Revised Wakeup and Sleep Scheme for PoDL

Andrew Gardner
Linear Technology

Presentation Objectives

PD Detection and Wakeup Current Signatures

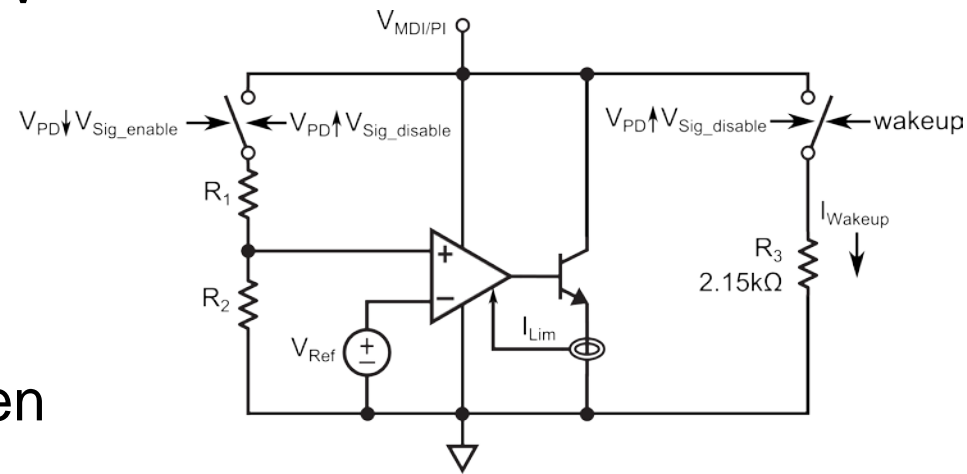
- Constant voltage detection signature moves from 3V to 4.3V to make room for V_{Sleep} .
- A resistor connected in shunt with the detection signature creates a wakeup current signature when a sleeping PD needs to be powered-up or when a PD exits RESET.
- Detection signature is enabled by a falling edge through $V_{\text{Sig_enable}}$.
- Detection signature and wakeup current signature are disabled by a rising edge through $V_{\text{Sig_disable}}$.

Simplified Schematic of Proposed Detection and Wakeup Signature

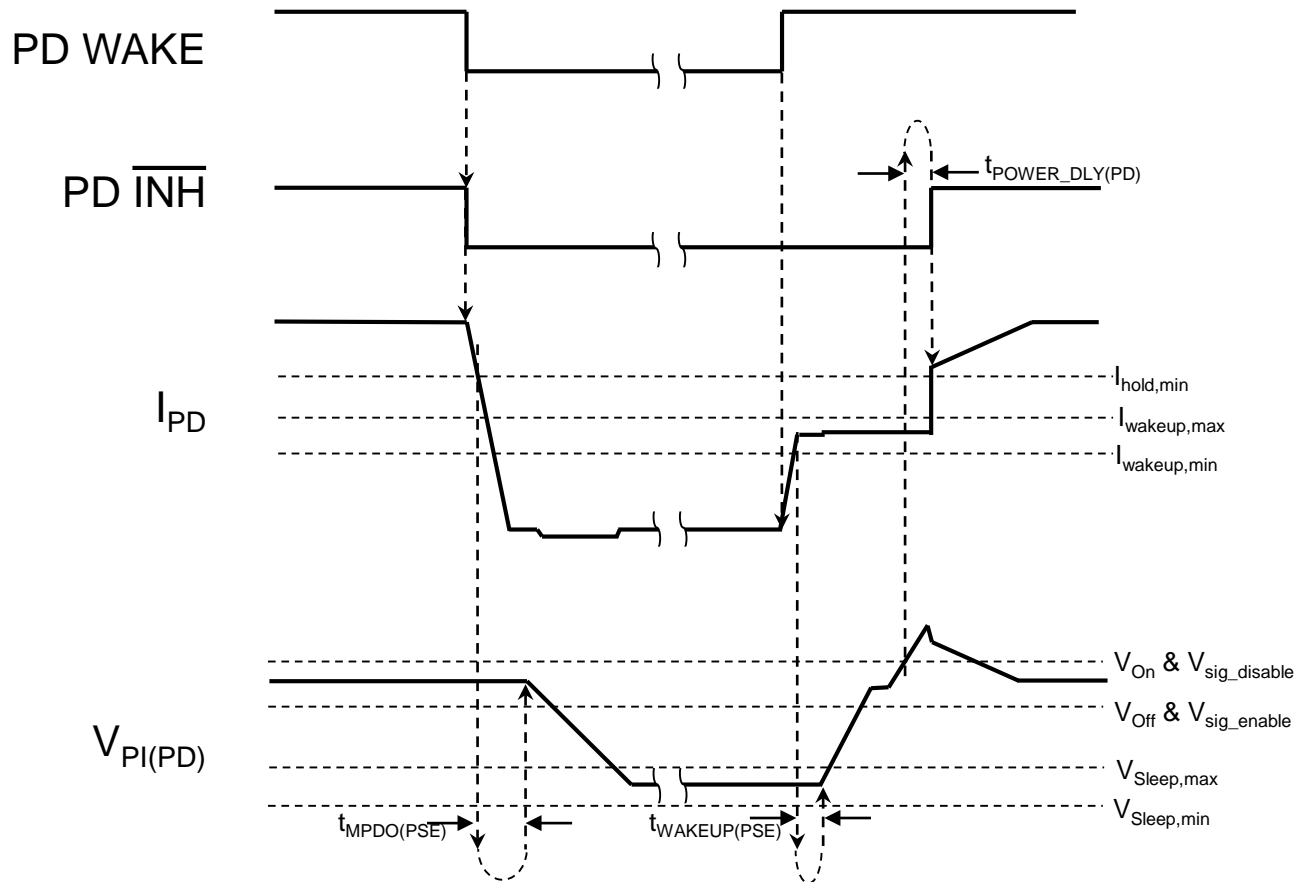
- A wakeup signature current switched in shunt with the detection signature device allows a sleeping PD to request power-up.
 - A PD that is hot-plugged into a sleeping PI also presents the wakeup current when exiting RESET in order to request initial power-up.

Proposed PSE Port State Machine

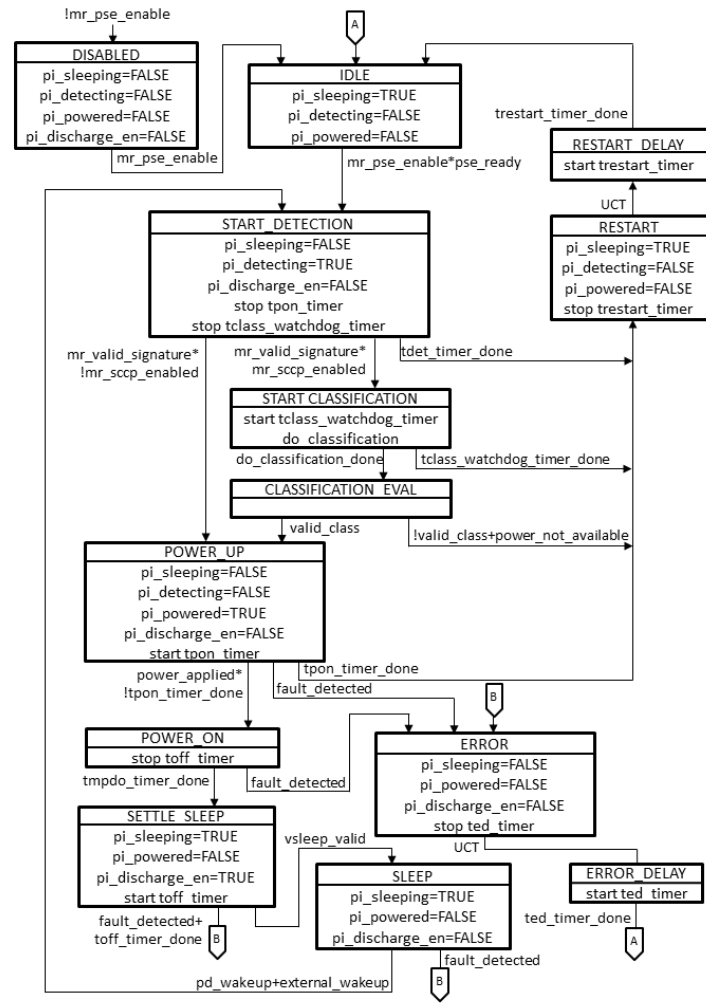
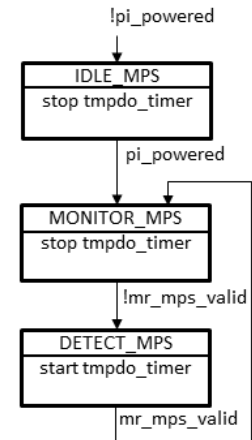
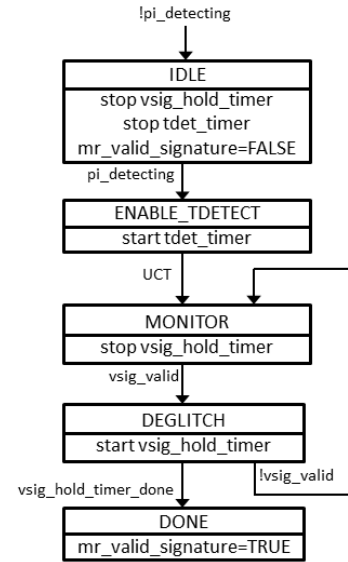
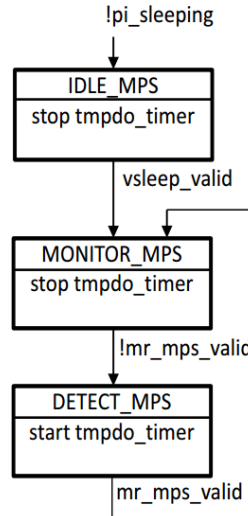
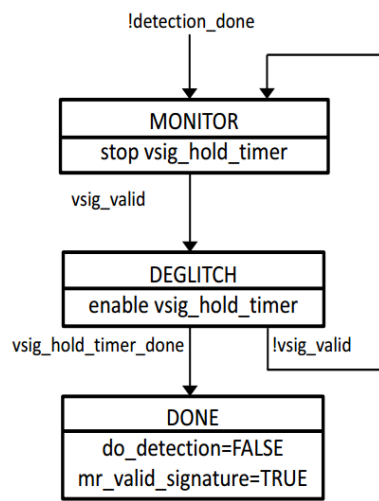
PSE, State Machine Changes for Proposed Wakeup and Sleep Scheme

New and Modified Variables for Proposed PSE State Machines

A Boolean variable that indicates the PSE has received an external wakeup request and shall re-detect the PD before re-applying the full operating voltage to the PI.

A Boolean variable that indicates the PSE has detected a valid wakeup current signature at the PI and shall re-detect the PD before re-applying the full operating voltage to the PI.

A Boolean variable that controls the circuitry the PSE uses to detect a valid PD signature. If true, the PSE forces a voltage limited detection current and senses the voltage at the PI in order to determine if a valid PD signature is present.

Proposed PD State Machine

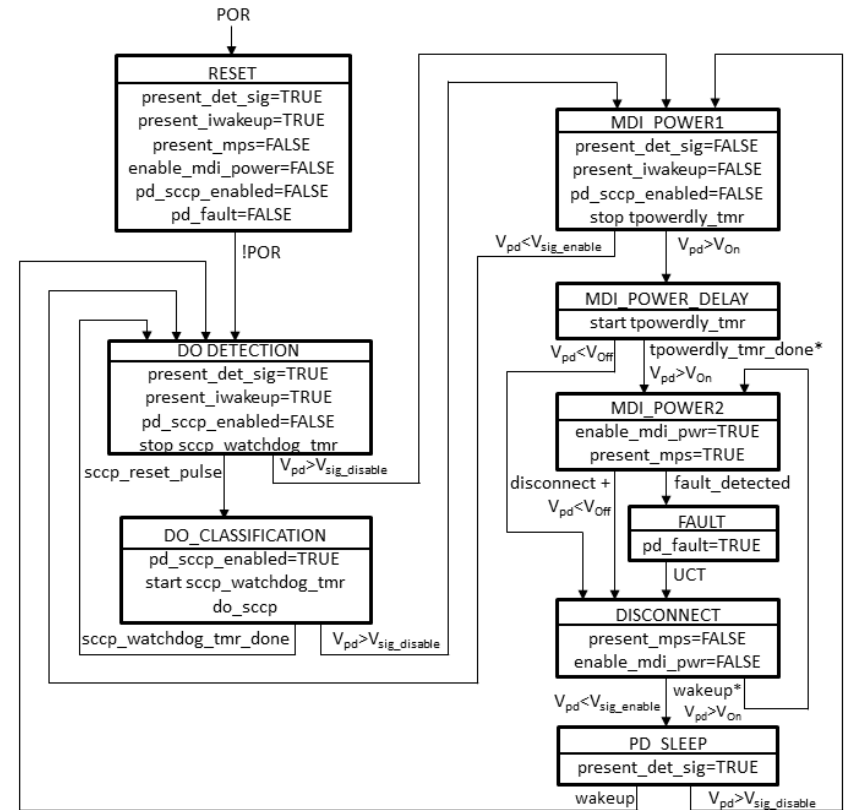
PD State Machine Changes for Proposed Wakeup and Sleep Scheme

A Boolean variable that indicates a PD no longer requires power ~~power~~ **the normal operating voltage** from the PI and has reduced its port current below the MPS threshold current, I_{Hold} .

A Boolean variable that indicates when a PD requires full power at the PI and when it is ready to go to sleep. True when full power is required and false when ready for sleep.
